We need a complete SWPPP per the State requirements. SWPPP needs to be submitted and reviewed prior to the approval of the subdivision and or prior to construction.

**IMPROVEMENT PLAN**  
DEVELOPER: CRAIG STANDING PH: 801-540-4989

**JACQUELYN ESTATES CLUSTER SUBDIVISION PH 1**  
LOCATED IN THE N.W. 1/4 OF SECTION 29, T.6N., R.2W., S.L.B.&M.  
WEBER COUNTY, UTAH

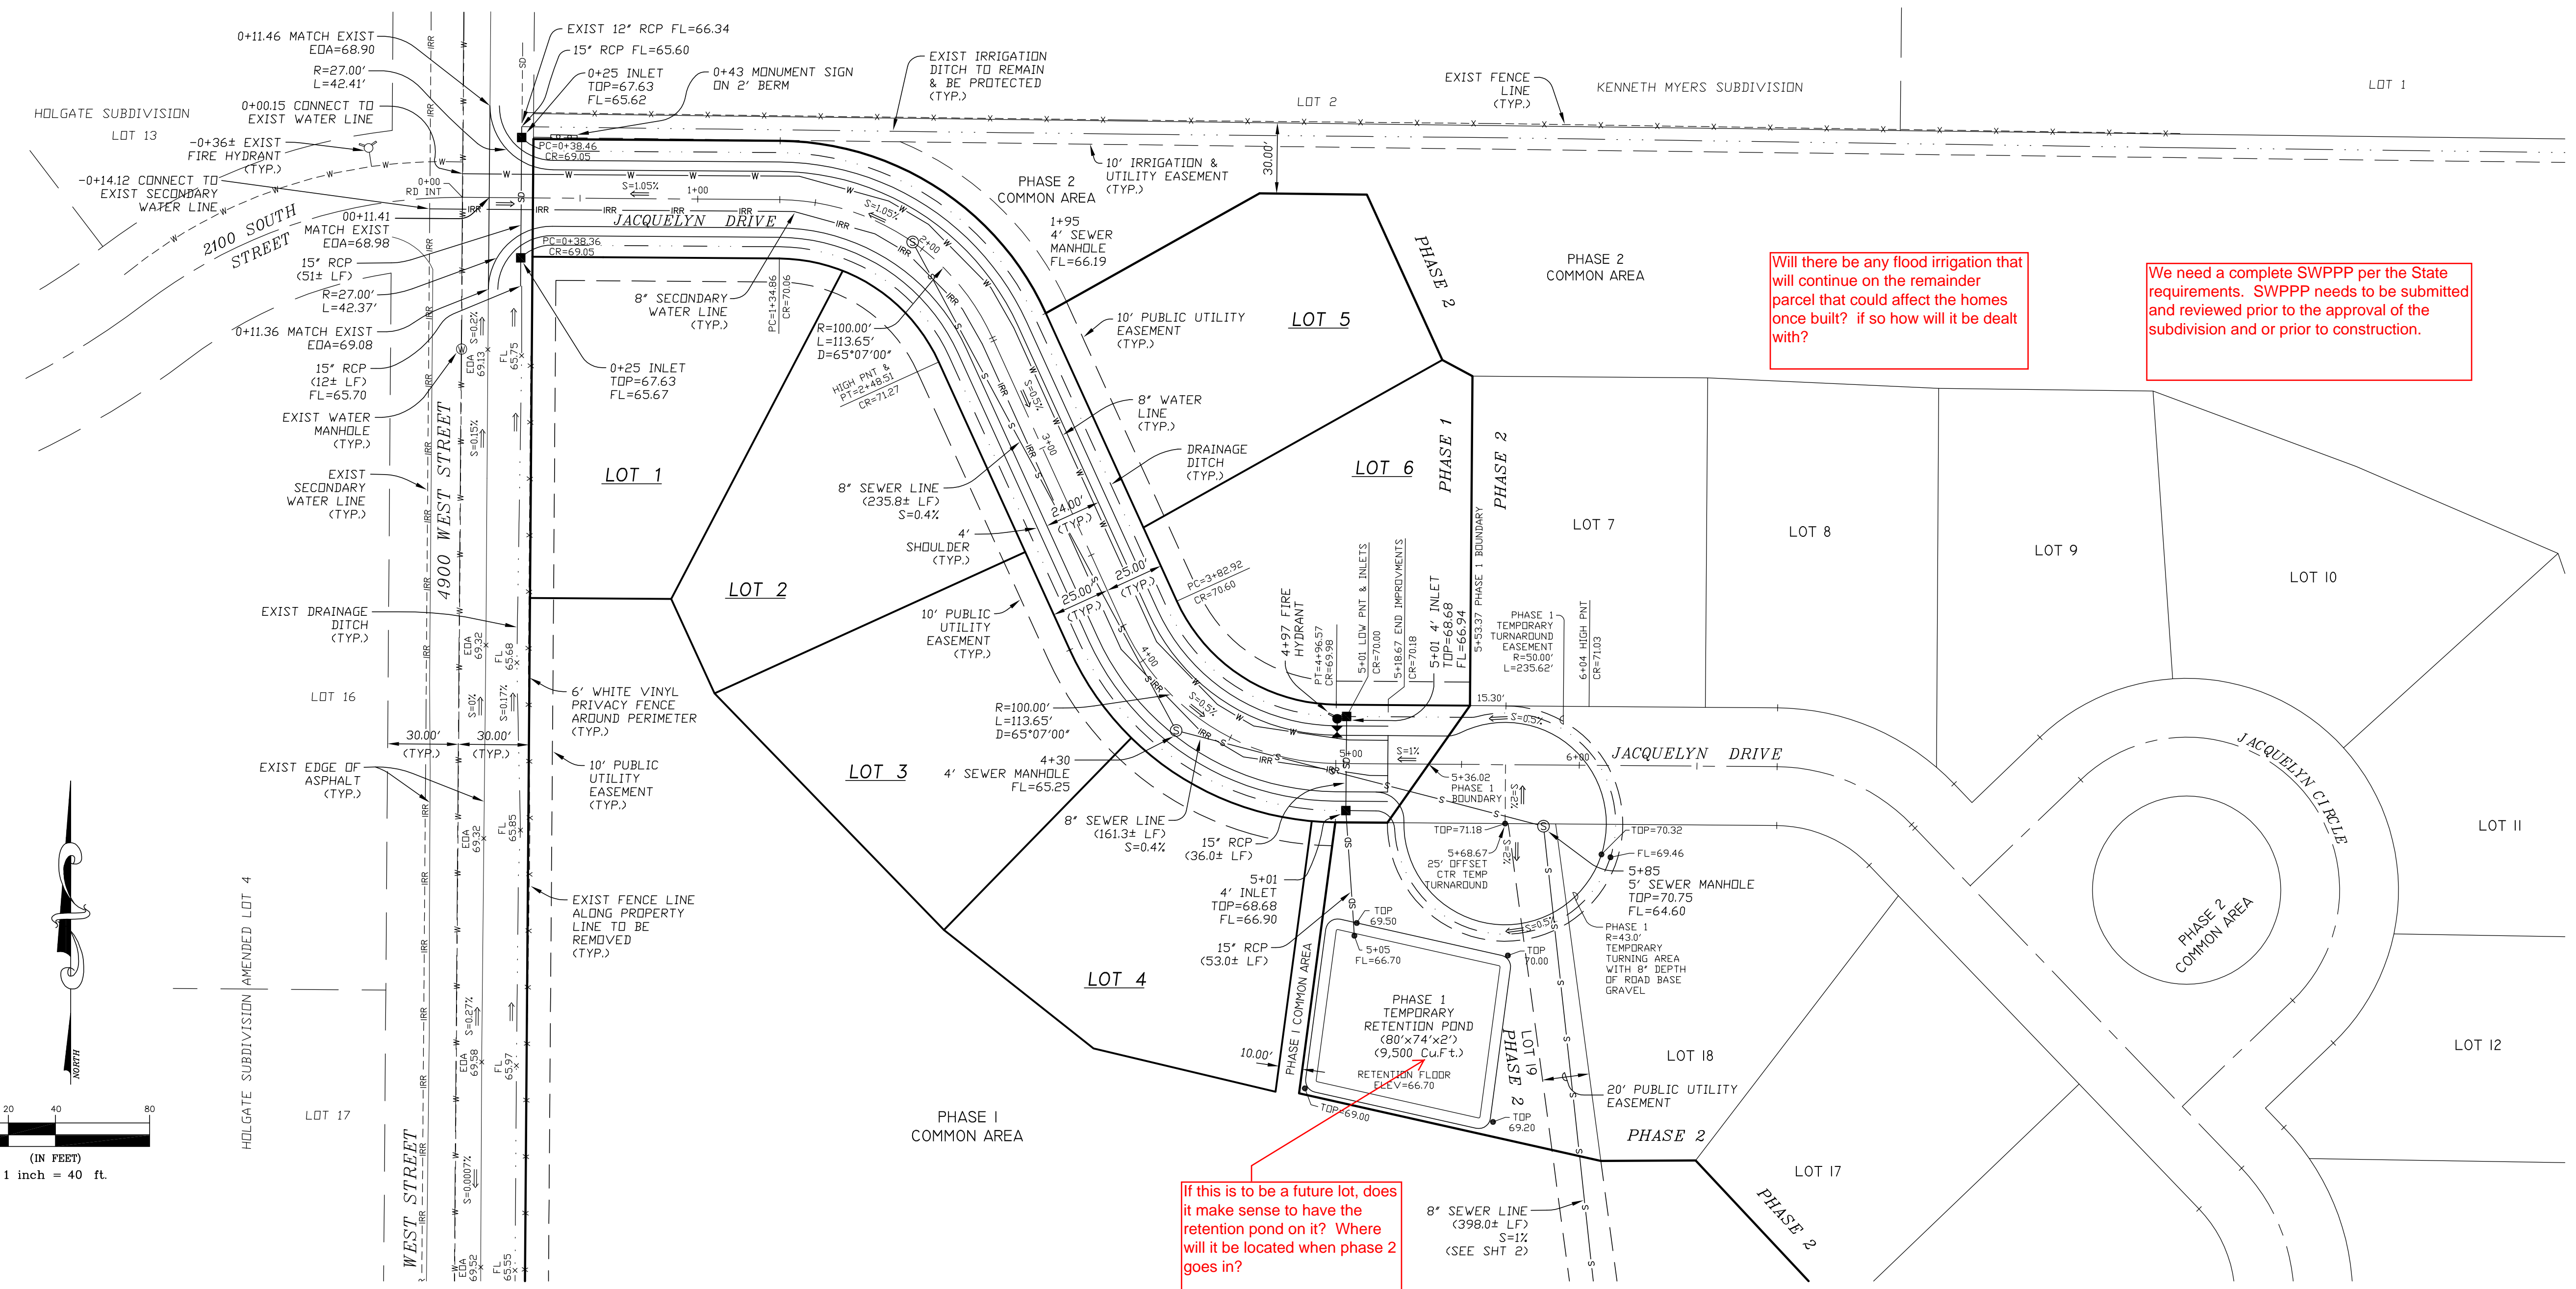
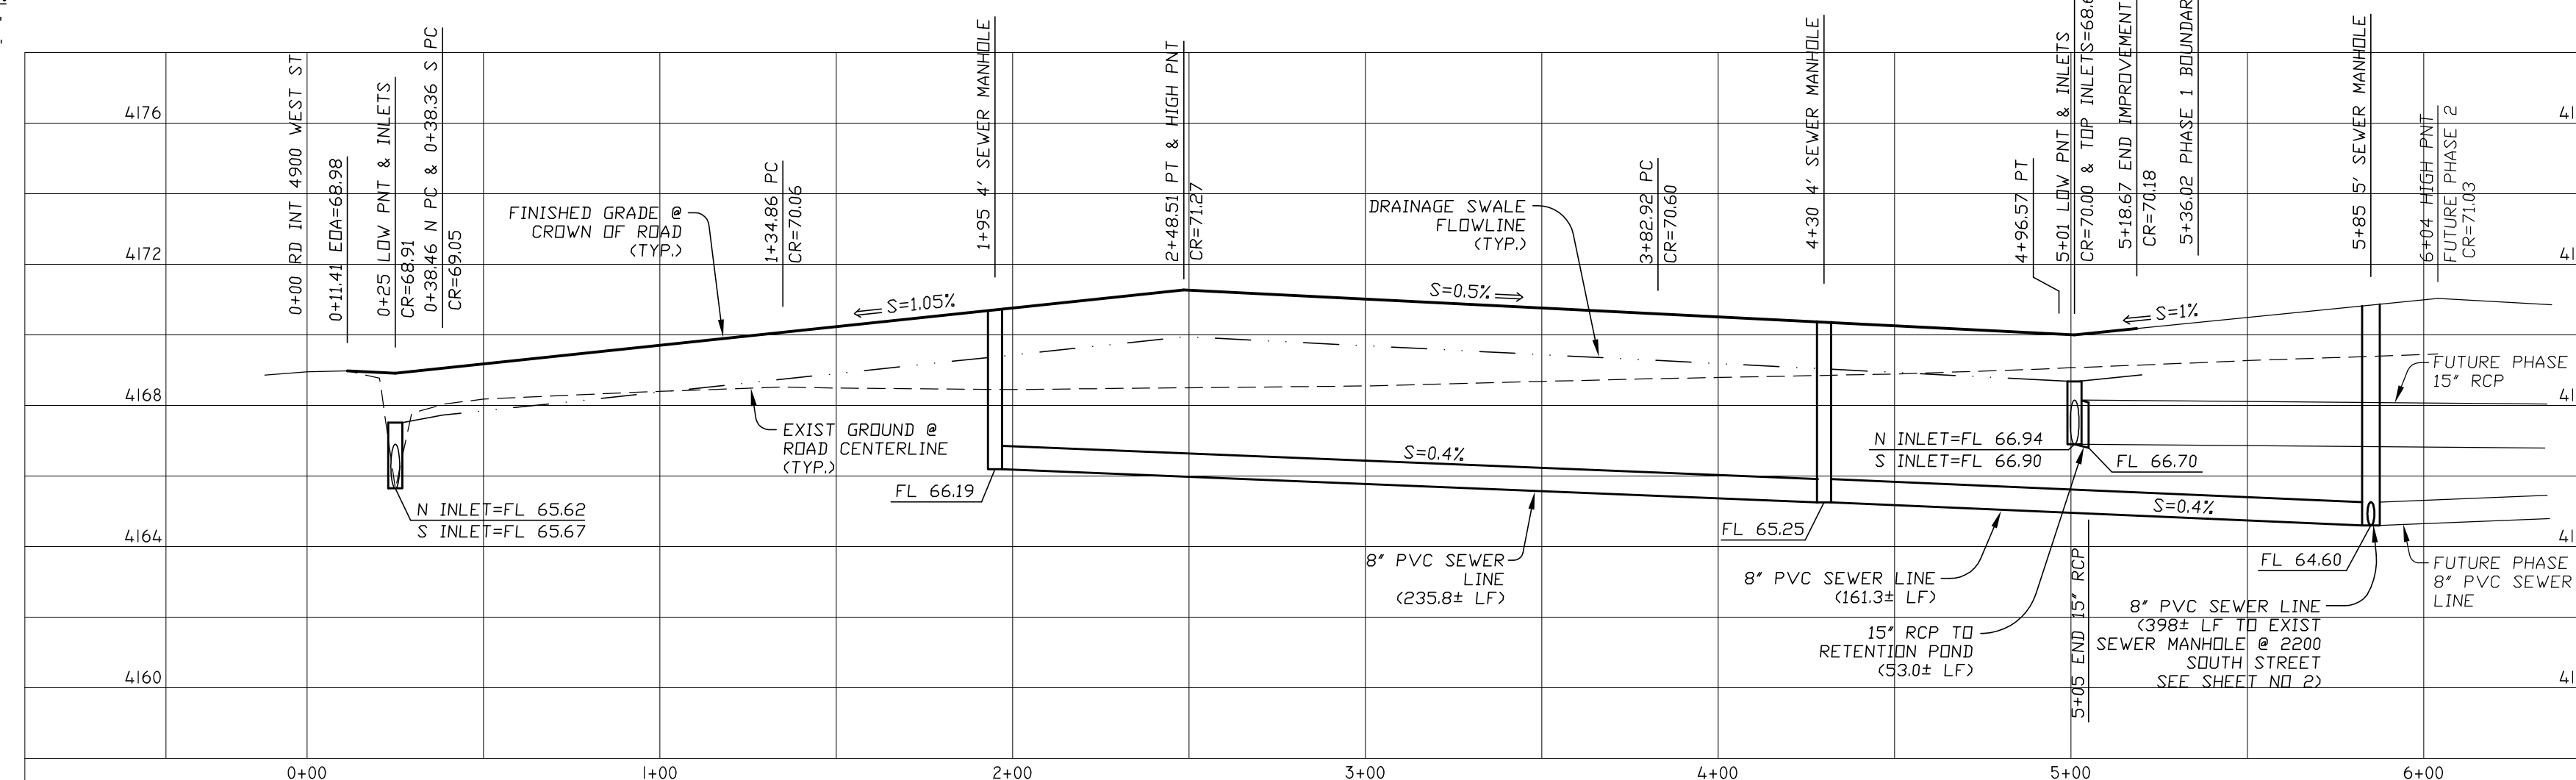
Will there be any flood irrigation that will continue on the remainder parcel that could affect the homes once built? if so how will it be dealt with?

If this is to be a future lot, does it make sense to have the retention pond on it? Where will it be located when phase 2 goes in?
